Design Review & Historic Preservation Board Meeting Agenda

1.a Design Review Application - MX-DRO - Wesley Homes Bradley Park, Phase 2 - REVISION A) APPLICANT REVISION SUBMITTAL
B) STAFF MEMO
C) PREVIOUS STAFF REPORT AND DRHPB DECISION MAY 2023

To:Design Review BoardFrom:Chris Beale, Senior PlannerRE:Wesley Bradley Park - Phase 2; Project #PLDR20230034Date:March 27, 2024Date of meeting:April 4, 2024

То:	Design Review and Historic Preservation Board
From:	Rachael N. Brown, Associate Planner
RE:	Puyallup Duplex Lot I and 2 Project # PLDDG20240023
Date of memo:	March 28, 2024
Date of meeting:	April 04, 2024

EXTERIOR ELEVATION - SOUTH END_OVERALL A3.1 1/8" = 1'-0"

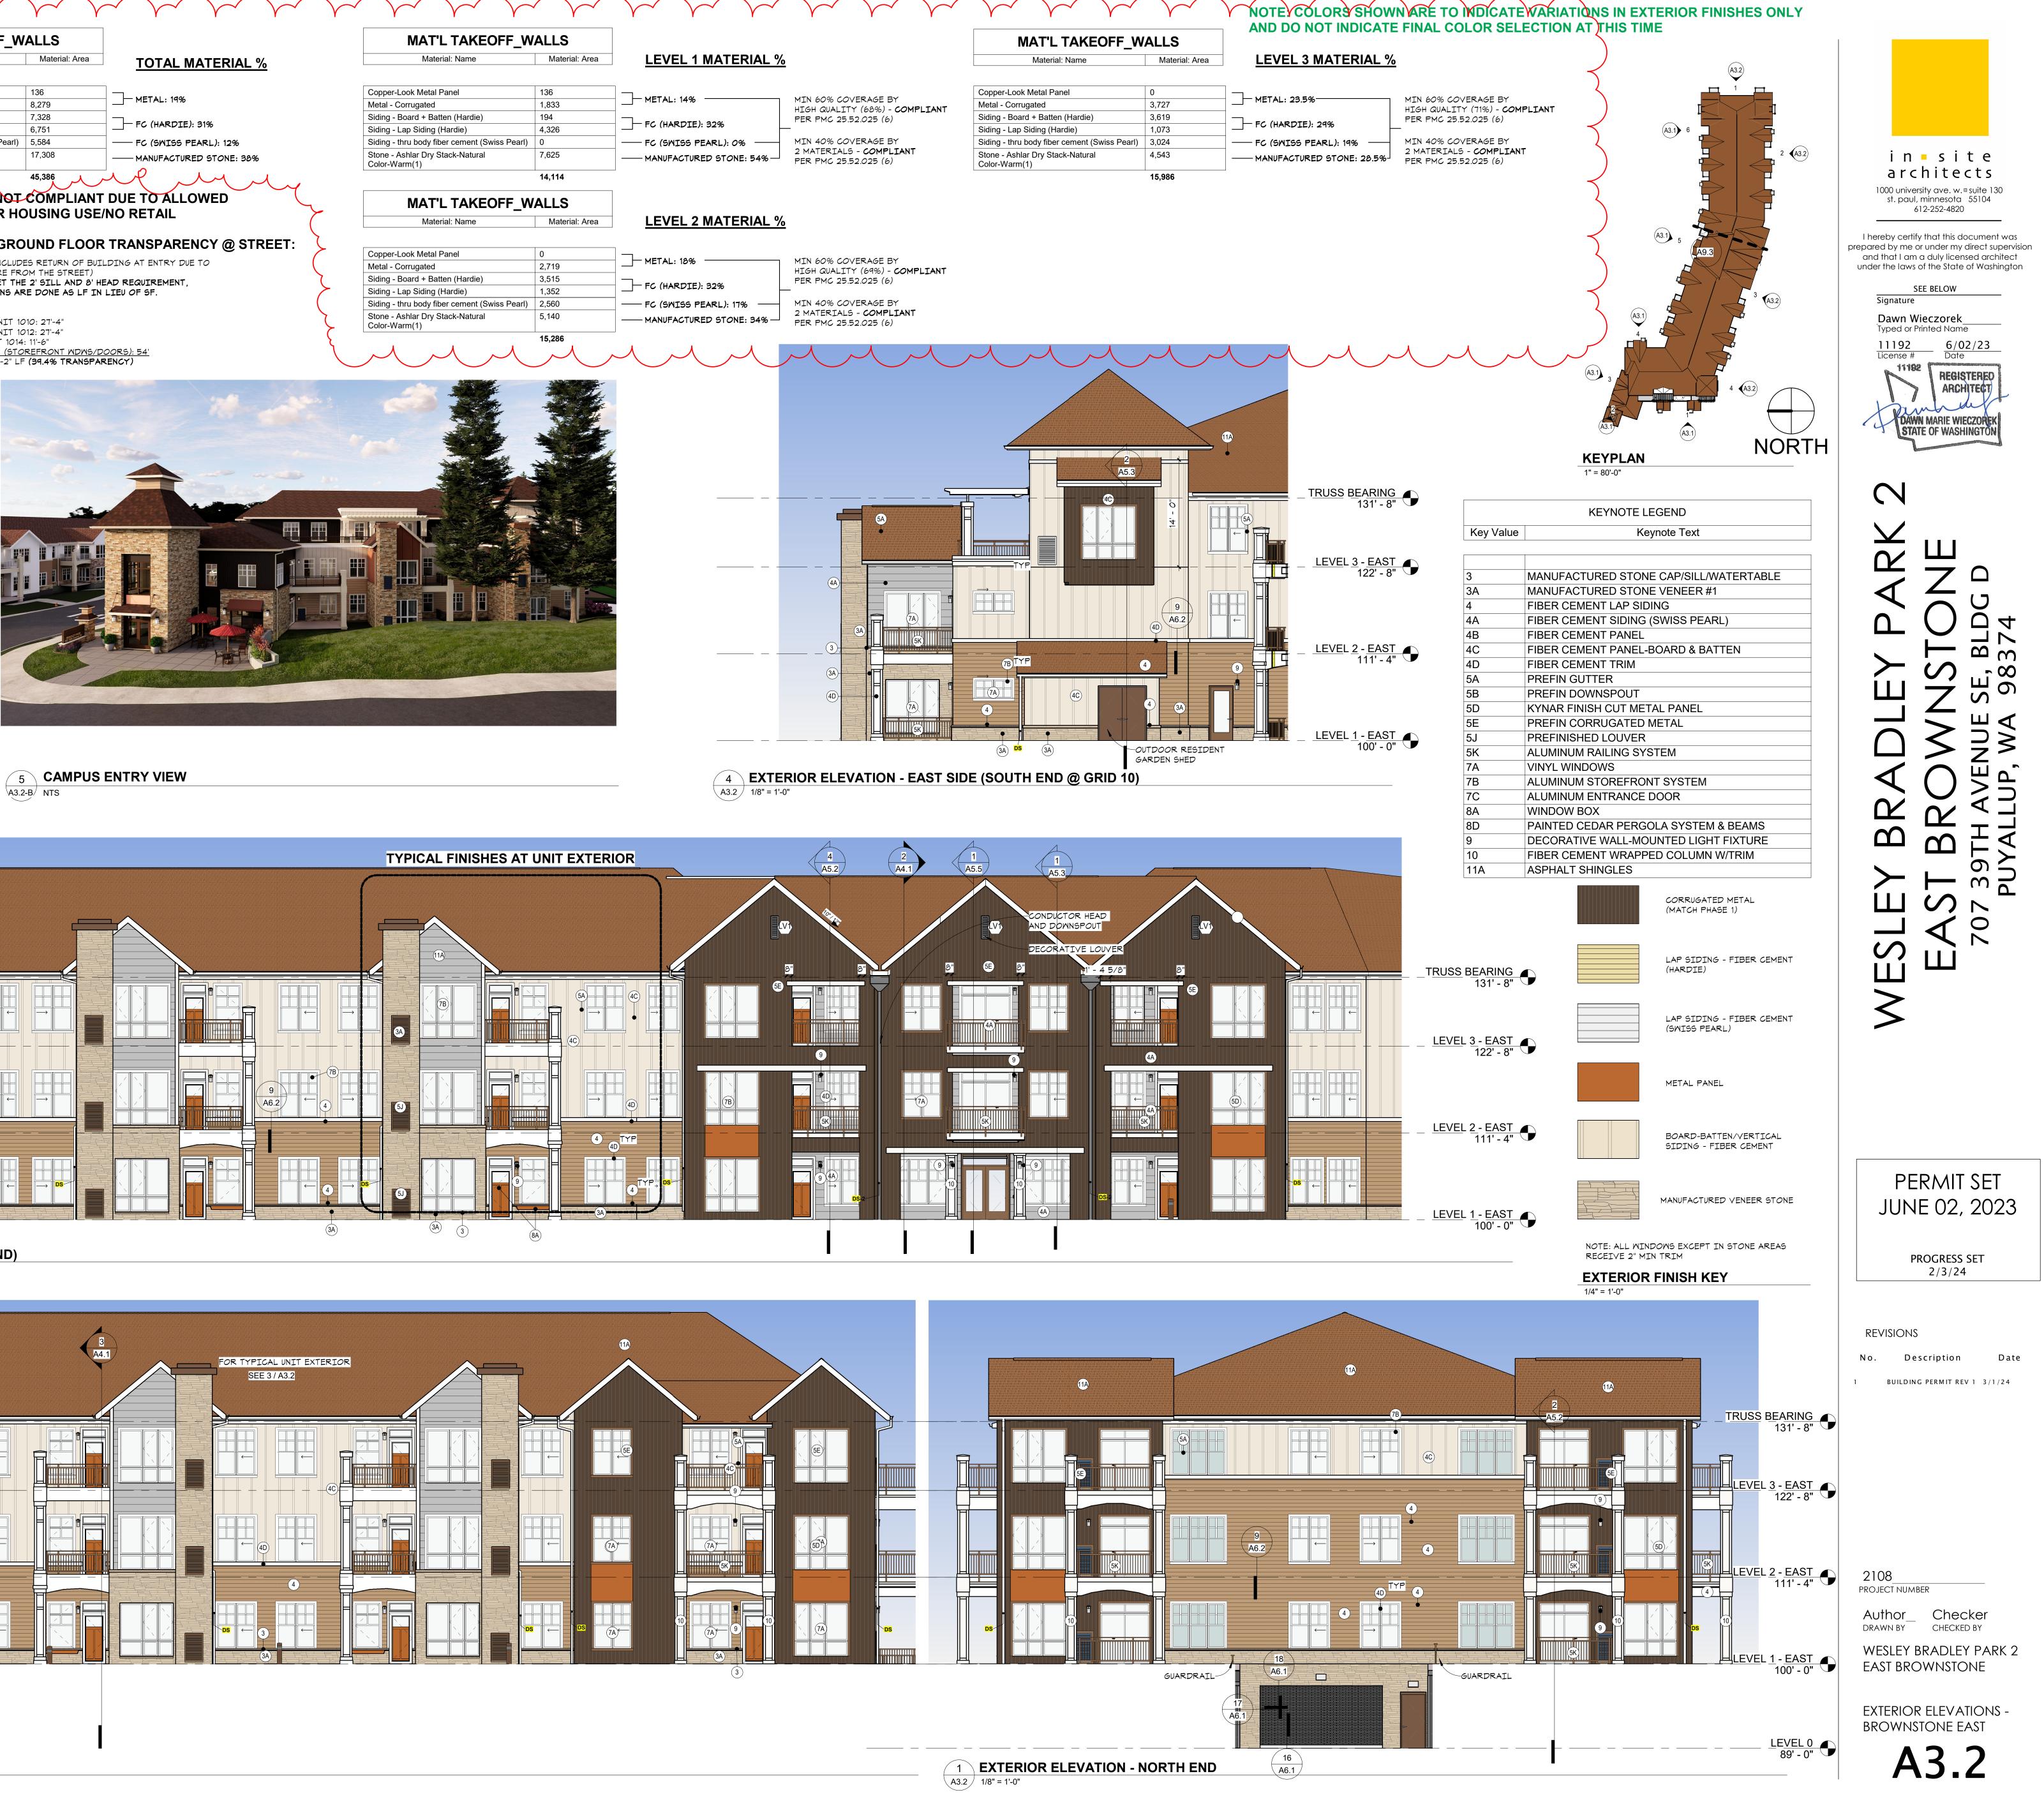
Horizontal changes of material from brick or stone to another material shall include a stone cap or a brick sill; the cap or sill shall project from the face of the building. A vertical change of materials shall occur at an interior corner or shall not occur within four feet of an exterior corner		Applicant does not address in the written narrative application. Head on elevation views of each building does not allow staff to visually confirm compliance. Applicant may be able to supply model view at Board meeting for further review.	Board should review with applicant to ensure compliance

Roofline Modulation				
Design Criteria	Complies?	Staff Analysis	Staff Recommendation	
If the continuous roofline exceeds 50 feet in length on a building with a flat, gabled, hipped or similar roof, or on a roofline with slopes of less than three feet vertical to 12 feet horizontal, the following methods shall be used: The height of the visible roofline must change at least four feet if the adjacent roof segments are less than 50 feet in length. The height of the visible roofline must change at least eight feet if the adjacent roof segments are 50 feet or more in length. The length of a sloped or gabled roofline must be at least 20 feet, with a minimum slope of three feet vertical to 12 feet horizontal.		Per applicant: "All main roofs are 4 1/2:12 pitched. Due the distance between the Brownstones and the frequency of the gabled porch entries, the roofline of the main roof is not even visible". See applicant narrative and elevations.	Board should review with applicant to ensure

- 1. Upper Floor Setbacks required for 3 stories and taller: now applicable. The third floor is stepped back 10' dimensioned from exterior wall to exterior wall. This area will be used mostly as decks for (2) residential units. The parapet has been kept fairly low so that the guardrail is more visible which provides a more layered look. Pergolas are also planned.

- 8. Roofline Modulation No change to roof pitches. The overall roof has been simplified as previously noted. All main roofs are 4 1/2:12 pitched. Due the distance between the Brownstones and the frequency of the gabled porch entries, the roofline of the main roof is not visible. At the revised south end, the sloped roof is interrupted by a flat wall extension and raised gabled tower element at the east.
